**Kimmeridge Oil & Gas Limited**  
**Objection to amendment of planning permission to drill at**  
**Broadford Bridge, West Sussex**

**By**  
**David K. Smythe**

10 August 2017

Figure 2. Celtique's Willow Prospect search area (red), compared with the search area available within PEDL234 if mature Kimmeridge Clay Formation is the target.

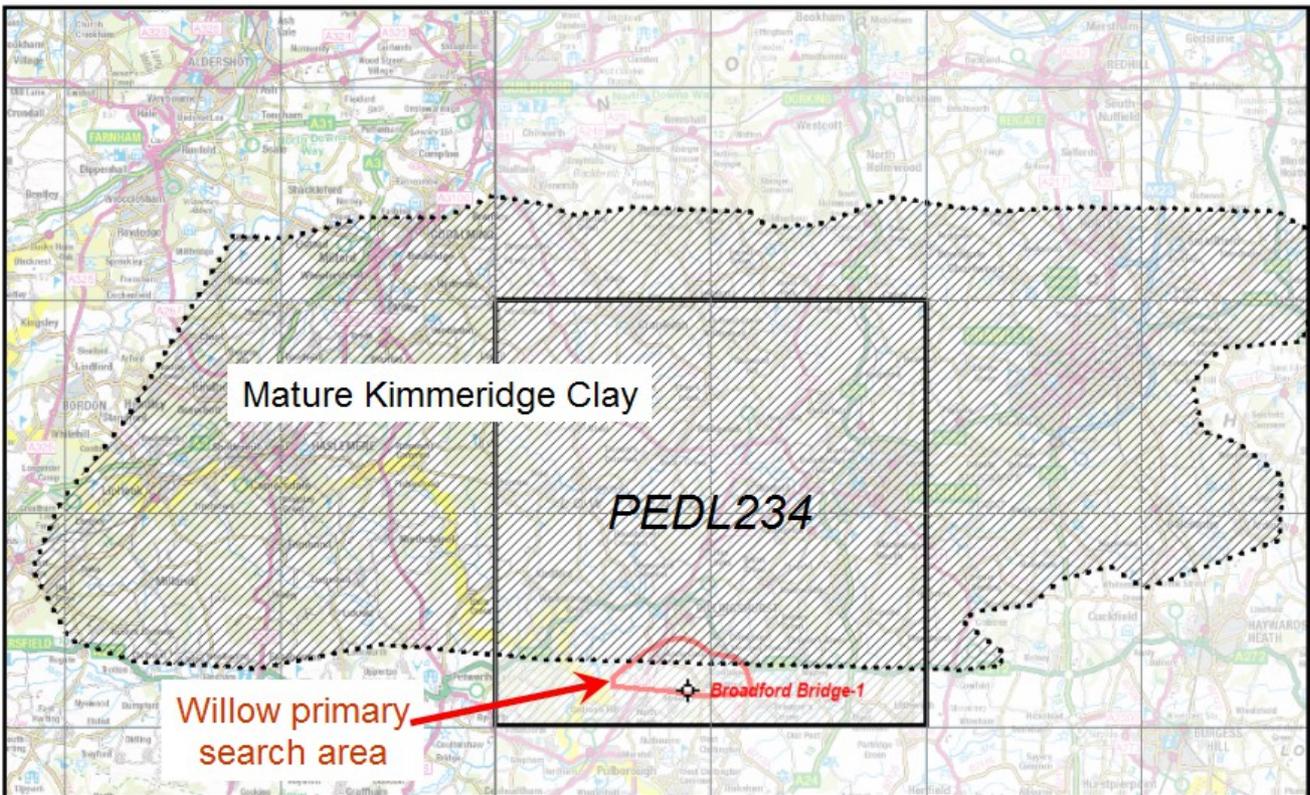
Firstly, in contrast to Celtique's well-defined conventional target, the Applicant's target, the Kimmeridge Clay Formation (KCF), is found below the whole of the licence area (Figure 2). There is no geological requirement or justification for using the existing well pad at Wood Barn Farm. Therefore the Alternative Sites Assessment carried out by Celtique, which is a material part of the planning approval, is superfluous, since the KCF is now the target.

The Wood Barn Farm wellpad is a poor location for testing the KCF, because it lies 1.2 km south of the limit of mature Kimmeridge shale as defined by the BGS (Figure 2). The only reason for the Applicant to have continued work at Wood Barn Farm seems to be the

Figure 3. Comparison of the original Celtique Energie well prognosis with the Applicant's prognosis. Red boxes indicate (a) the fault zone predicted by Celtique where section would be missing, and (b) text on the right where the Applicant expected to penetrate a fault zone.

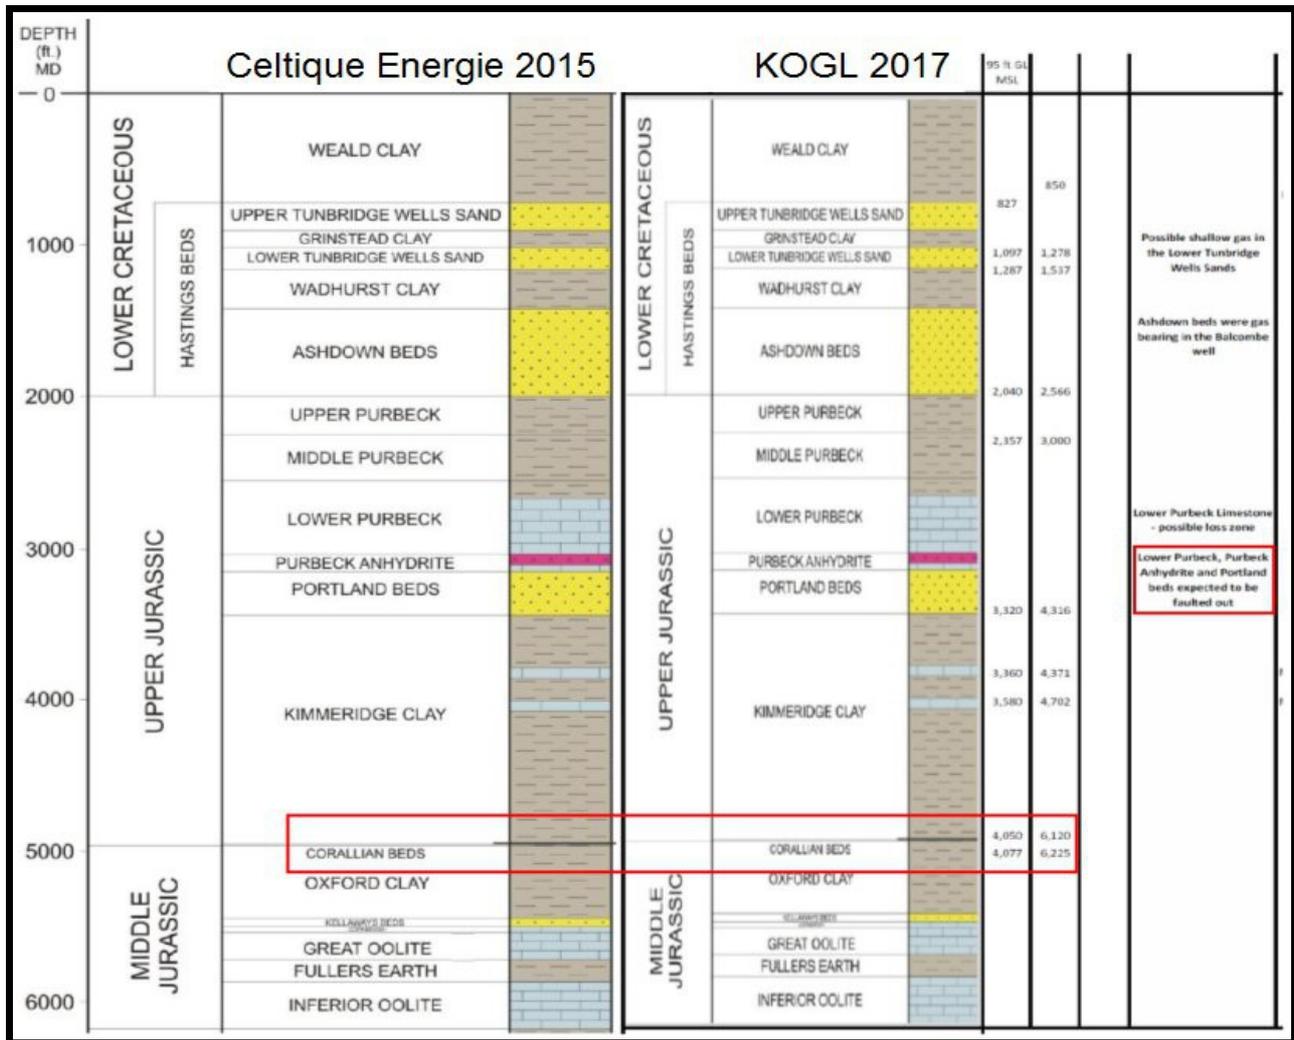
The right-hand side of Figure 3 shows that the Applicant simply re-used the same old Celtique Energie diagram (the Applicant's Waste Management Plan, 17 February 2017, fig. 2.1), but with different depth figures shown on the right. Here there are two columns; the true vertical depth, and the driller's depth measured along the hole, on the left and right, respectively. The Applicant has drilled a highly deviated hole. It also expected to penetrate a fault zone, where it states (as highlighted in the red rectangle of Figure 3) "Lower Purbeck,

*Purbeck Anhydrite and Portland beds expected to be faulted out*". These layers, shown in light blue, crimson and yellow in the middle of the geological column, should therefore have been omitted from the column. In contrast, the rock layers correctly omitted by Celtique in its column on the left (within the lower red rectangle) should properly have been included in the column on the right. The Applicant's prognosis is therefore misleading.

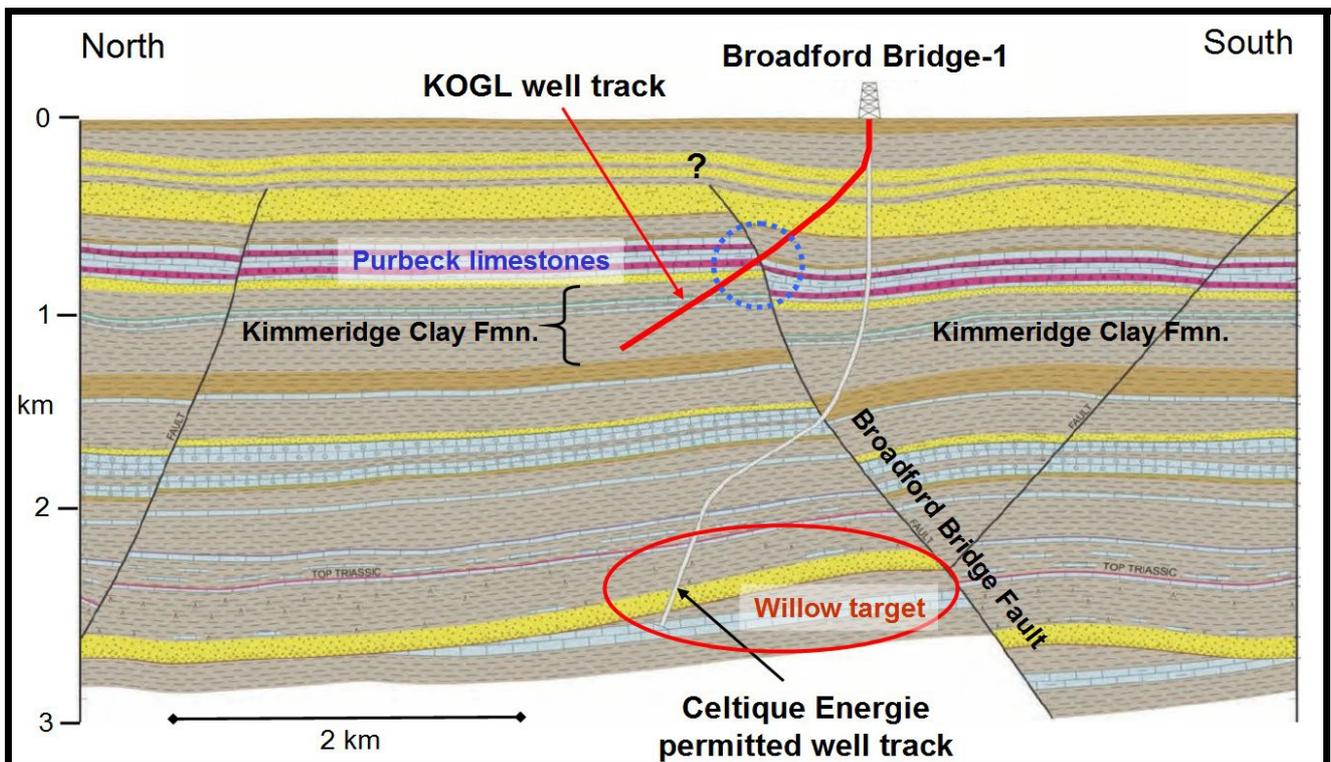
The Applicant's well, in contrast, deviated significantly from the vertical just below the surface, and then passed through the Broadford Bridge Fault at a much shallower depth than Celtique Energie's proposed wellbore. It then penetrated the Kimmeridge Clay Formation (KCF), with its two thin so-called limestone beds, at an oblique angle of around 44° to the vertical.

The Applicant has drilled through the Broadford Bridge Fault at around 800 m depth (Fig. 4), but at a location some 500 m east of the seismic line on which Figure 4 is based. The interpretation of the geology by Celtique Energie, shown in Figure 4, is based on the seismic line CE-11-02 which they acquired in 2011. The location of this line is shown in Figure 5. The Applicant's well crossed three near-coincident seismic lines some 400-500 m NE of the pad, but these lines are of very limited use since they cross the wellpath at an angle of about 80°.

It has been reported (RNS Number 6747N, UK Oil & Gas Investments PLC, 10 August 2017) that the original well developed a washout zone, where the hole diameter is larger than the 8½ inch open hole, and where drilling fluid was being lost. This zone is located within the blue dashed circle (Fig. 4) where the hole traverses the Purbeck limestones, and which are in turn faulted by the Broadford Bridge Fault. The problem was so serious that a new sidetracked well (Broadford Bridge-1z) has been drilled to bypass the washout.

Figure 5. Generalised locations of seismic reflection data (dotted green lines) around Broadford Bridge-1. Grid is at a 1 km interval. The proposed Celtique well track is shown in blue; the well track drilled by UKOG in red. OS map base copyright acknowledged.

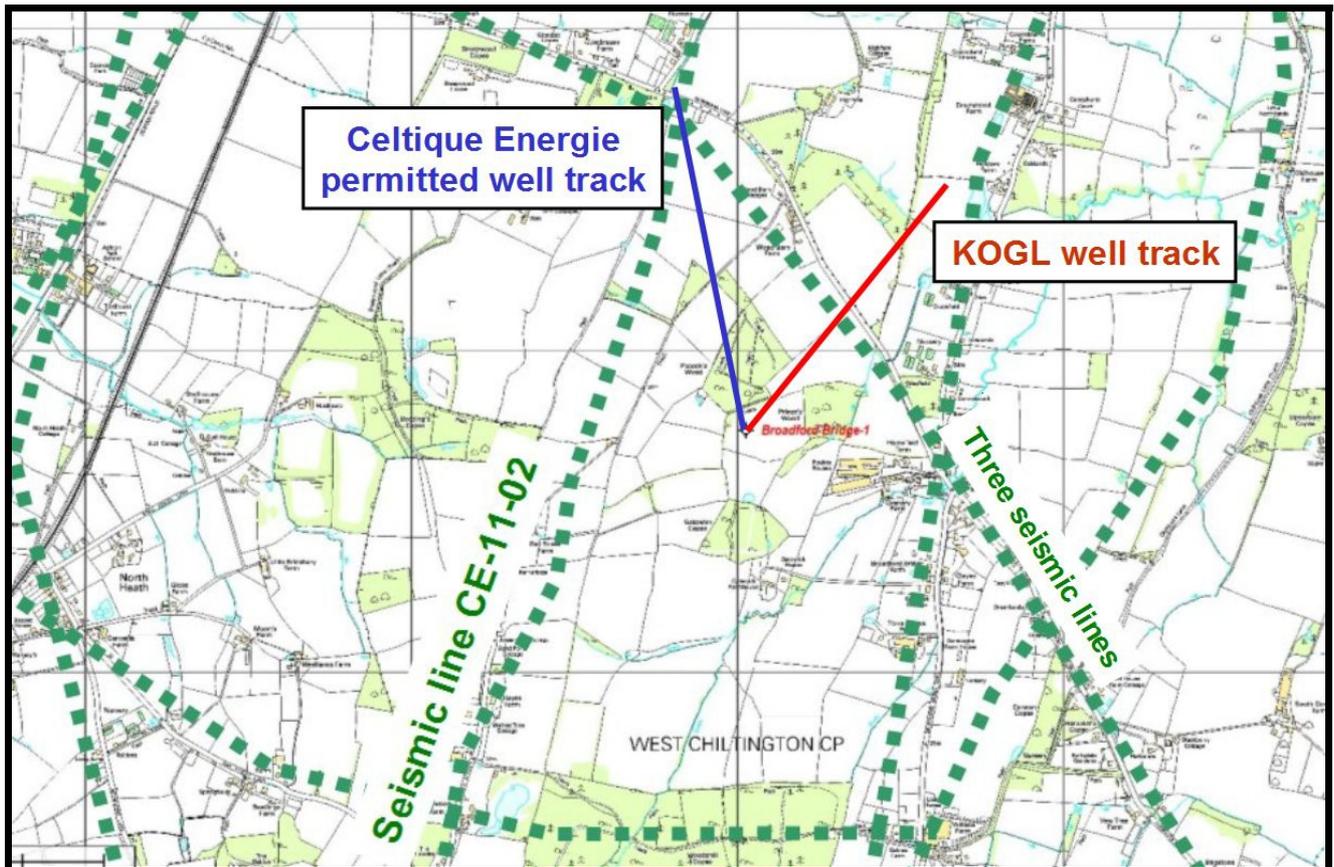
Figure 5 shows that the azimuthal direction of drilling was to the NE (red welltrack), in contrast to Celtique Energie's proposed track to the NNW (blue welltrack).
